## **Te Komiti mō te Waeture me te Haumaru / Regulatory and Safety Committee**

### **OPEN MINUTE ITEM ATTACHMENTS**

# Objection to Stormwater Works at 116A Forrest Hill Road, Forrest Hill

## Objection to notice issued under section 181 LGA

# Photos of No. 116A

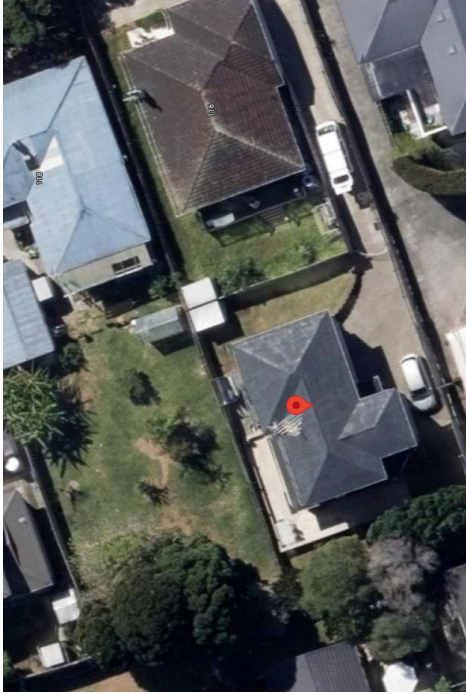
# Error – capacity of existing infrastructure

- Existing infrastructure set up to service two homes
- Existing pipe from No. 116A to Raines Ave is 160mm diameter. Proposed pipe from No. 118 to No. 116A is 225mm diameter.
- Existing connection is by way of non-access chamber. Only suitable for 2 inlet pipes under Stormwater Code of Practice. Both inlets being used by No.s 116 and 116A.
- In 2007, the Council told Mr Dukeson the existing pipe from No. 116A to Raines Ave had capacity to service 2 homes **only**
- Risk of increased flooding at No. 116A as a result
